CITY OF WATERVILLE

ADDENDUM #1

August 14, 2014

The following shall be noted for Request for Bids Standing Seam Metal Roof System

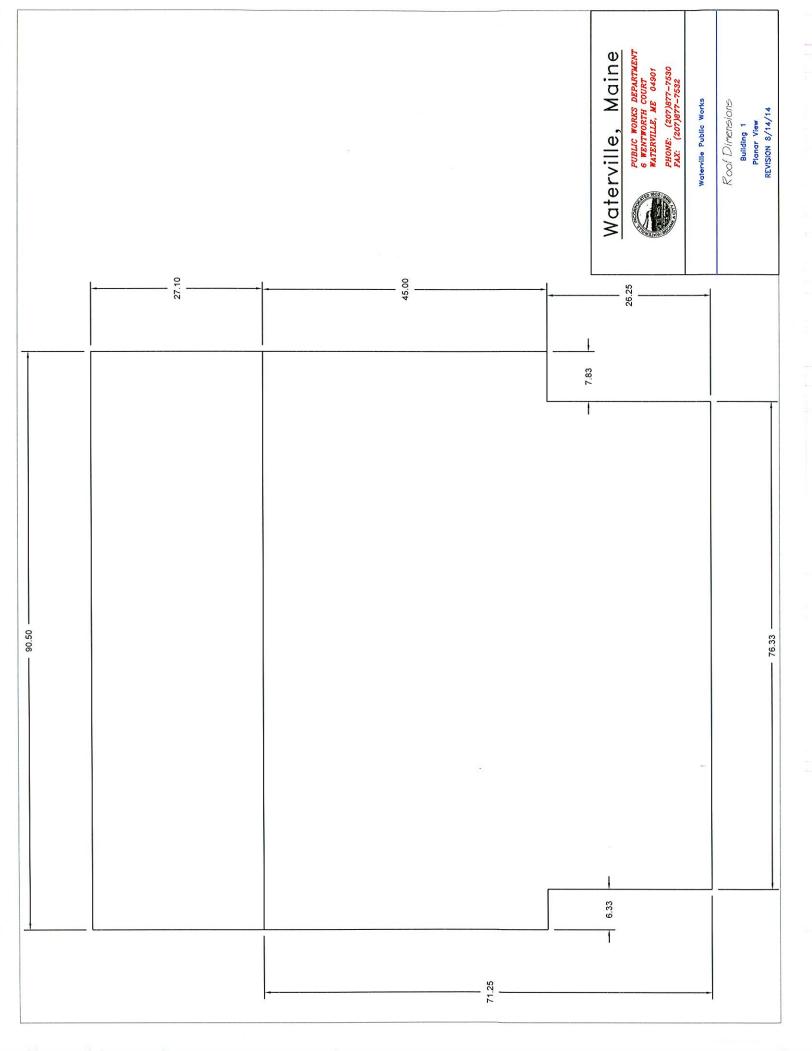
- D. Provide separate price for double snow and ice guards on north side of building.
- 5) Warranty
 - B. Provide 2 year Installers Warranty for workmanship.
- 6) See attached revised roof diagram, dimension error on the original, roof is 8,500 sq.ft.+/-.
- 7) Use attached revised Bid Submittal Form which provides for pricing of Mill Finish Galvalume and color coated.
